Customer	: CC-DAR01 Dart Aerospace Ltd.		Drawing Name	: D412-664-203	
Job Number	: 29271		Part Number	: D412664203	
Estimate Number	: 10804		Drawing Number	: NCR 095	
P.O. Number	: N/A		Project Number	: N/A	
This Issue	: 06/11/2006	S.O. No.	: N/A	Drawing Revision	: N/A
Prsht Rev.	: NC		Material	: N/A	
First Issue	: N/A		Due Date	: 13/11/2006	
Previous Run	: 29190		Qty:	1	Um: Each
Written By	:				
Checked & Approved By	:				
Comment	:

DESIGN <i>b</i>	DRAWN BY <i>b</i>	DART AEROSPACE LTD HAWKESBURY, ONTARIO, CANADA		
CHECKED <i>MM</i>	APPROVED <i>MM</i>	DRAWING NO. DSI 9357	REV. A SHEET 1 OF 2	
DATE 06.10.25		TITLE CROSSTUBE SUPPORT CHANGE	SCALE NTS	
A	06.10.25	NEW ISSUE

## **DART SERVICE INSTRUCTION**

TO AMEND INSTALLATION INSTRUCTIONS IIN-D212-664 Rev. C AND  
 INSTRUCTIONS FOR CONTINUOUS AIRWORTHINESS ICA-D212-664 Rev. 2  
 REF. CANADIAN STC: SH01-9  
 REF. FAA STC: SR01298NY

**FIGURE 1 - CROSSTUBE SUPPORT  
INSTALLATION ON D412-664-203**

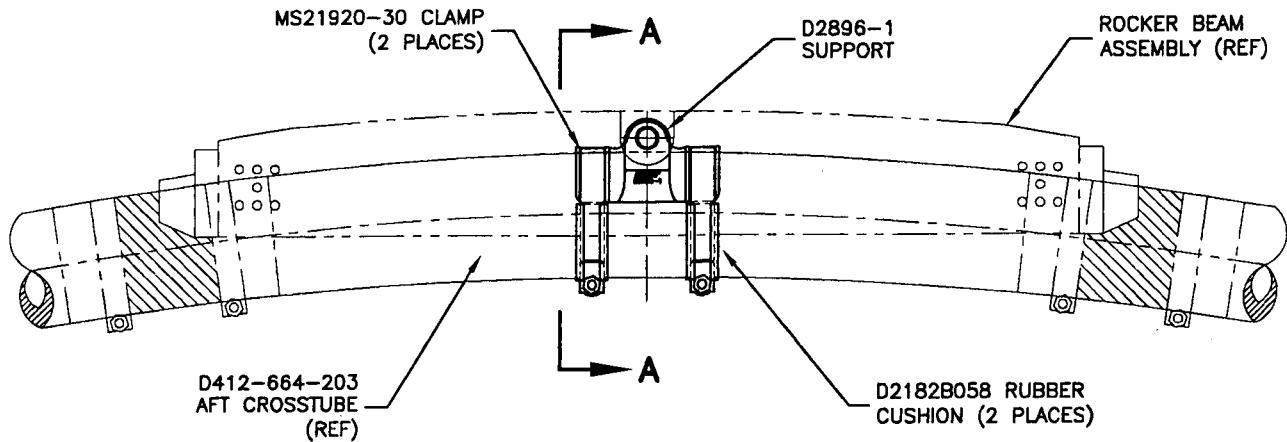
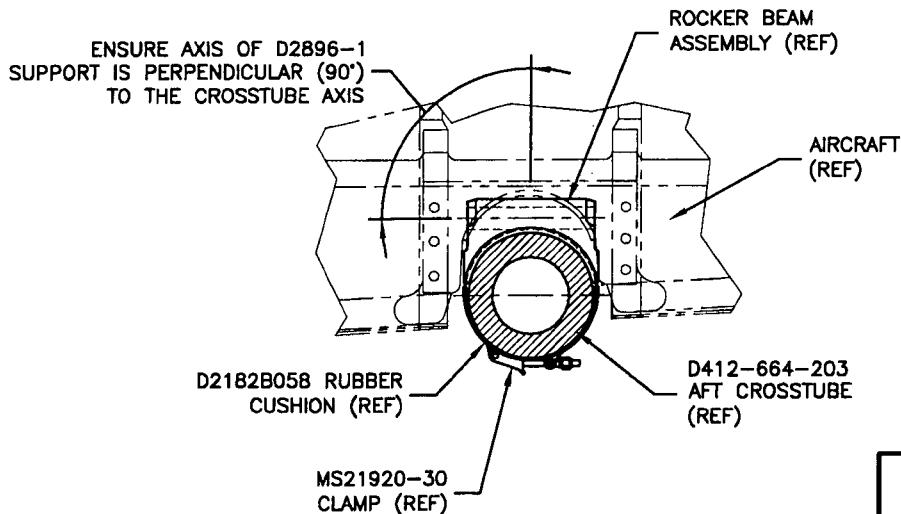
For D412-664-203 Aft Crosstubes at CHG 002 or later, the D2856-600-1087 Abrasion Strip has been removed, the center D2896-1 Support has been bonded onto the crosstubes using Magnobond 6398 and D2182B058 Rubber Cushions have been installed underneath the MS21920-30 Clamps. Amend Parts List of IIN-D212-664 Section 5 and ICA-D212-664 Section 32.8 as follows:

To prevent the center support from shifting on D412-664-203 Crosstubes at CHG 001, the D2896-1 Support should be removed and re-installed as follows:

- 5) Apply a 0.03" to 0.06" thick layer of Magnobond 6398 underneath D2896-1 Support and re-install the Support on the crosstube as shown in Figure 1. Use rocker beam assembly to properly align the D2896-1 Support. Ensure the Rocker Beam Assembly can move freely without any friction with other parts. Install a D2182B058 Rubber Cushion on each MS21920-30 Clamp. Position and secure the D2896-1 Support on the crosstube using MS21920-30 Clamps. Torque clamps 80-100 in-lb. Let the D412-664-203 Crosstube Assembly cure before re-installing the crosstube or the aircraft.
